**CITY OF MERIDIAN
FINDINGS OF FACT, CONCLUSIONS OF LAW
AND DECISION & ORDER**

In the Matter of the Request for Annexation of 8.20-Acres of Land with an R-8 Zoning District; and Preliminary Plat Consisting of 28 Building Lots and 6 Common Lots on 8.20-Acres of Land in the R-8 Zoning District for Kingstown Subdivision, by Kimley-Horn.

Case No(s). H-2022-0045

STAFF REPORT	
COMMUNITY DEVELOPMENT DEPARTMENT

KINGSTOWN SUBDIVISION - PRELIMINARY PLAT
PRELIMINARY PLAT
MERIDIAN, IDAHO

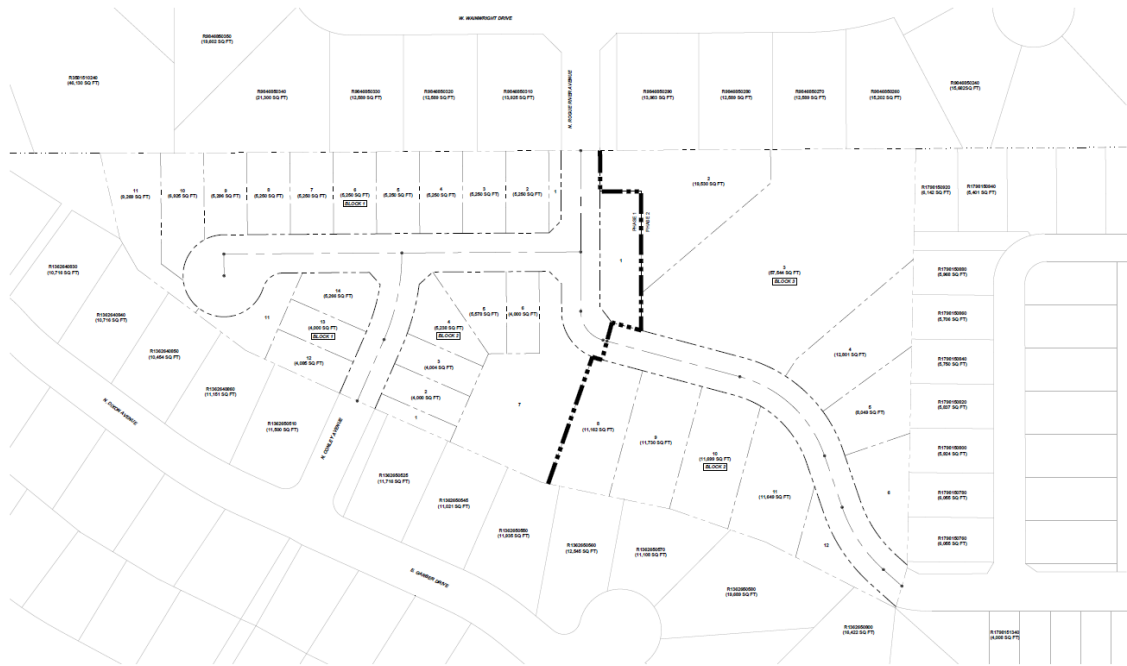
Although the gross density for the overall development at 3.42 units/acre is within and at the low end of the desired density range in the MDR designation, the lot sizes proposed in the first phase along the north boundary are not compatible in size and provide a poor transition to existing lots. The proposed lots in Phase I are mostly 4,000 square feet (or 0.09 acre), while the abutting existing lots in Zebulon Heights and Champion Park subdivisions are 0.25+ acre in size. The transition from proposed to existing homes along the north boundary range from a 2:1 to a 5:1 transition. A better transition in lot sizes should be provided. No buffering or screening is proposed.

The lot sizes proposed along the eastern boundary in Phase II are much larger/wider and range from a 1:1 to 1:4 transition. A better transition in lot sizes should be provided in this area as well. No buffering or screening is proposed.

Although Lot 15, Block 1 and Lot 11, Block 2 meet most of the *quality* standards for open space areas listed in UDC 11-3G-3A, these areas do not demonstrate integration into the development as a priority and appear to be “leftover” areas that aren’t developable as building lots and don’t meet the *qualified* open space standards listed in UDC [11-3G-3B](#). Lot 15, Block 1 could qualify toward the open space requirement if an additional 70 s.f. is added to the lot in accord with UDC 11-3G-3B.1a. Lot 11, Block 2 could qualify if 715 s.f. is added to the common lot in accord with UDC 11-3G-3B.1a; or, a community garden could be added to the existing lot in accord with UDC 11-3G-3B.1; or, a minimum 20’ x 20’ plaza could be added to the existing lot, including hardscape, seating, lighting in accord with UDC 11-3G-3B.1. The plans should be revised as recommended by Staff to meet the minimum qualified open space standards.

- b. Reducing the number of lots along the northern boundary or overall within the development to provide a better transition to existing lots to the north;

- a. Remove Lot 10, Block 1 along northern boundary to provide a better transition in lot sizes to the north; no one parcel to the north shall have more than 3 portions of a lot adjacent to it; inclusion of DA provisions that prohibit any windows on the second story of homes that face north along the northern boundary of the subdivision west of Rogue River in Block 1; and the developer to encourage backyard landscaping to assist in buffering to the larger homes/lots to the north.

- d. Increase the size of Lot 15, Block 1 by 70 square feet to meet the qualified open space standard of 5,000 square feet in UDC 11-3G-3B.1a.
 - e. Remove Lot 10, Block 1 along northern boundary to provide a better transition in lot sizes to the north; no one parcel to the north shall have more than 3 portions of a lot adjacent to it.

- e. Increase the size of Lot 15, Block 1 by 70 square feet to meet the qualified open space standard of 5,000 square feet in UDC 11-3G-3B.1a.
 - f. Lot 11, Block 2 does not meet the qualified open space standards listed in UDC 11-3G-3B – the plans should be revised to comply through one of the following options: 1) add 715 s.f. to the common lot in accord with UDC 11-3G-3B.1a; or, 2) include a community garden in the common lot; or, 3) include minimum 20' x 20' plaza in the common lot, including hardscape, seating, and lighting in accord with UDC 11-3G-3B.1. *If the lot is enlarged, the plat shall also be amended accordingly.*

- g. Remove Lot 10, Block 1 along northern boundary to provide a better transition in lot sizes to the north; no one parcel to the north shall have more than 3 portions of a lot adjacent to it.

KINGSTOWN SUBDIVISION - PRELIMINARY PLAT
EXISTING TREE PLAN
MERIDIAN, IDAHO

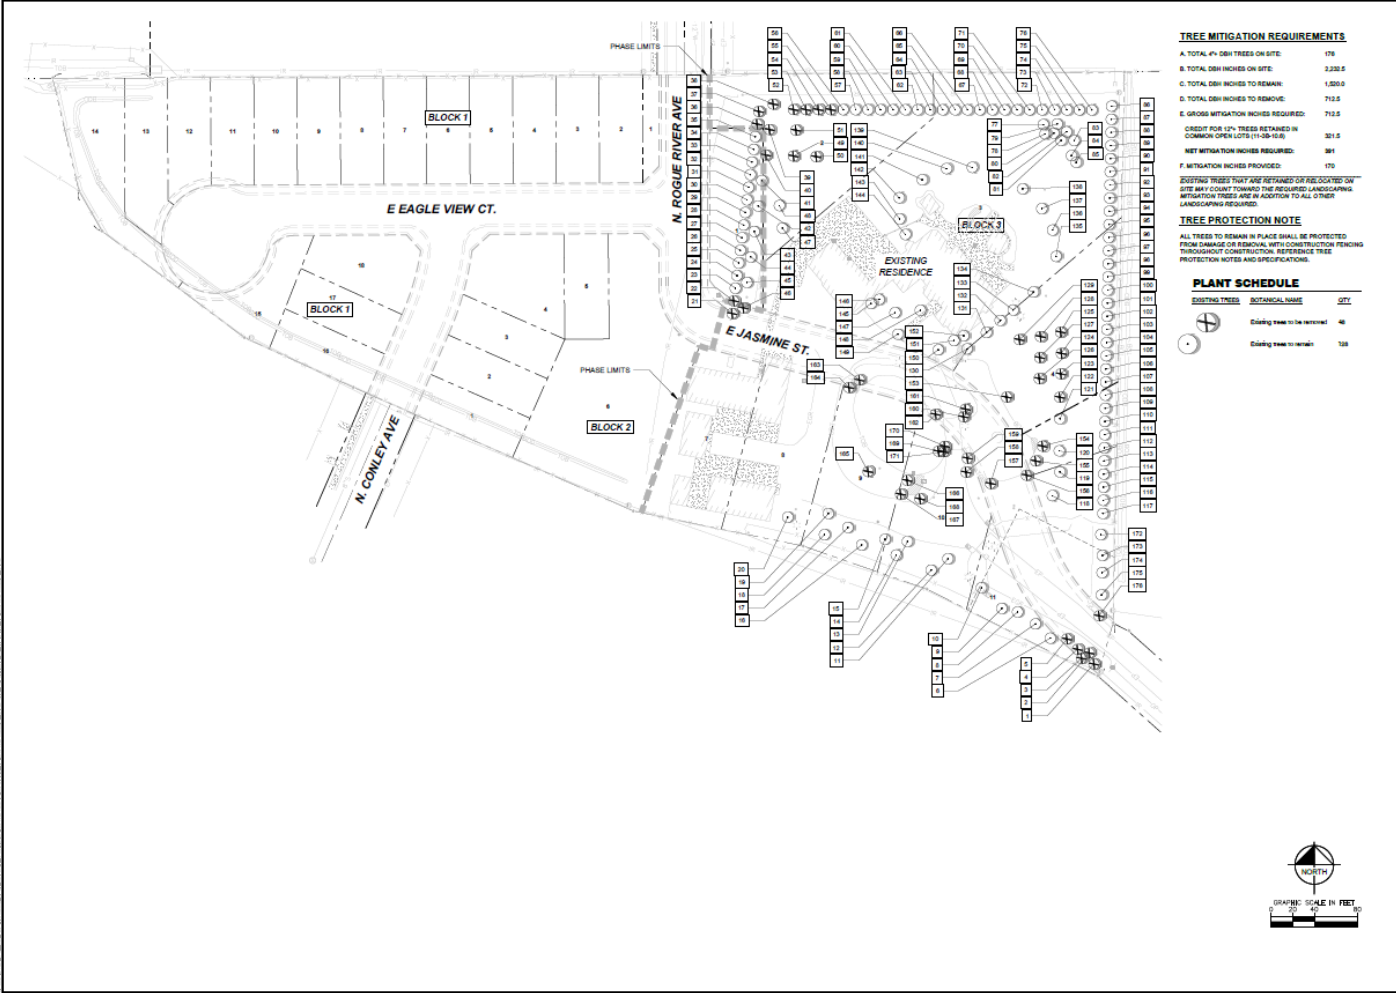
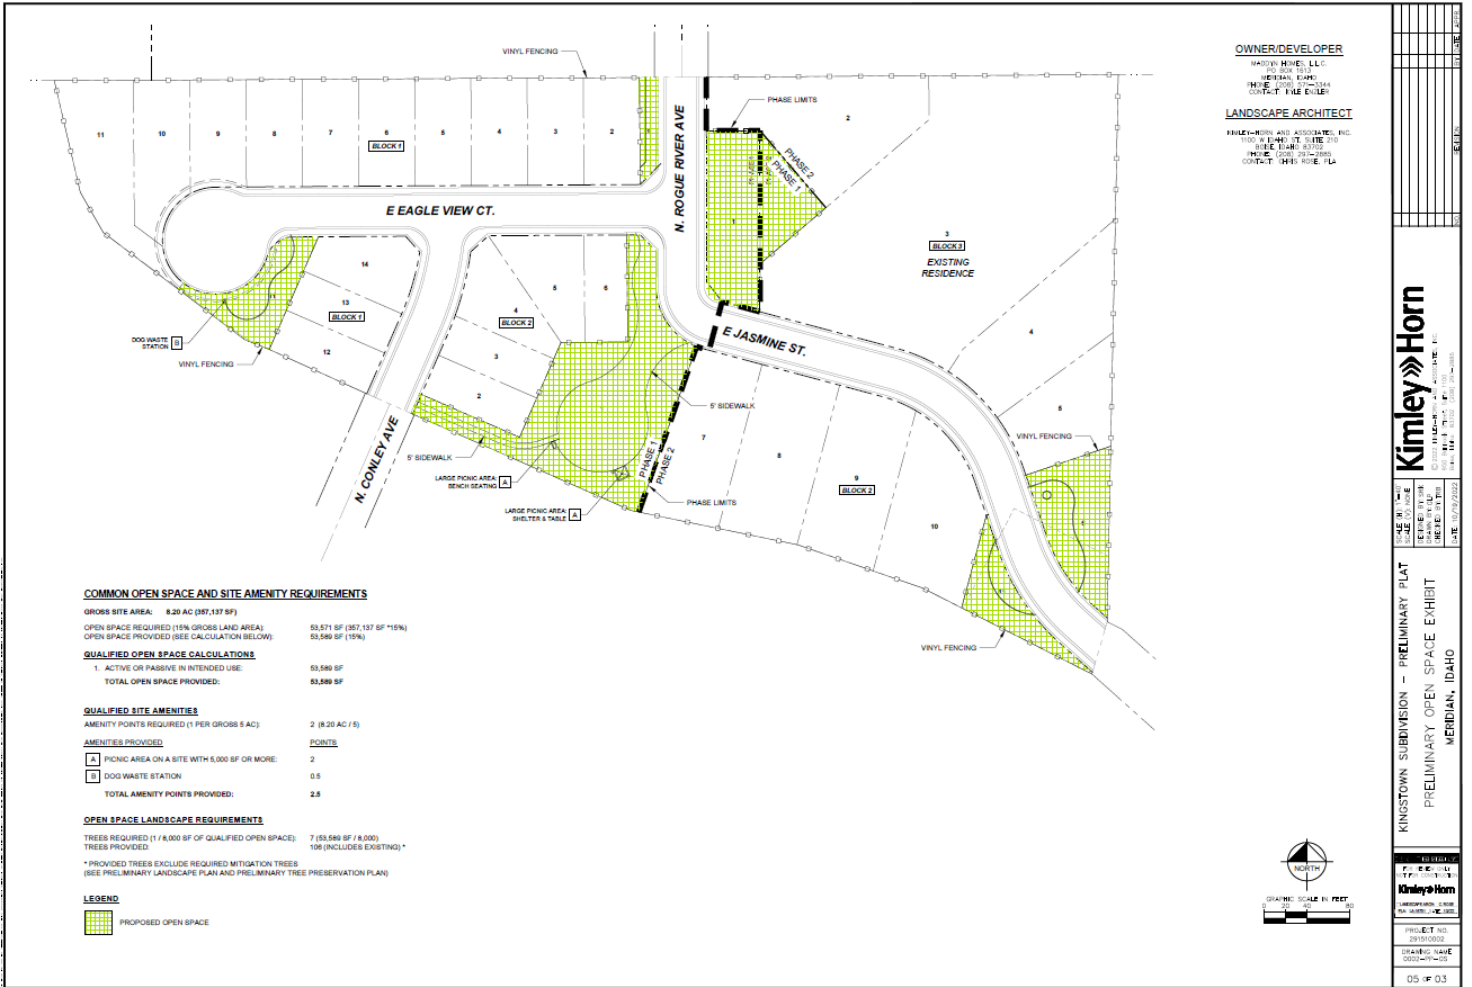
There is a total of 176 existing trees on the site totaling 2,232.5 caliper inches (see existing tree inventory and plan in Section VIII.D). A total of 1,520 caliper inches are proposed to remain with 712.5 caliper inches proposed to be removed. **A total of 391 caliper inches are required for mitigation as set forth in UDC [11-3B-10C.5](#); a total of 170 is provided, which is 221 less than required. Staff recommends one (1) 2-inch caliper tree is provided in the front and back yards of each building lot toward the mitigation requirement, which would leave 109 caliper inches remaining that could be provided in common lots, or Alternative Compliance could be requested to this standard for the remaining mitigation trees (see UDC 11-5B-5 for more information).**

- b. Provide one (1) 2-inch tree in the front and back yards of all building lots and an additional 109 caliper inches of trees on the site in common areas in accord with the mitigation standards listed in UDC [11-3B-10C.5](#); or, apply for Alternative Compliance to this standard (see UDC 11-5B-5 for more information).
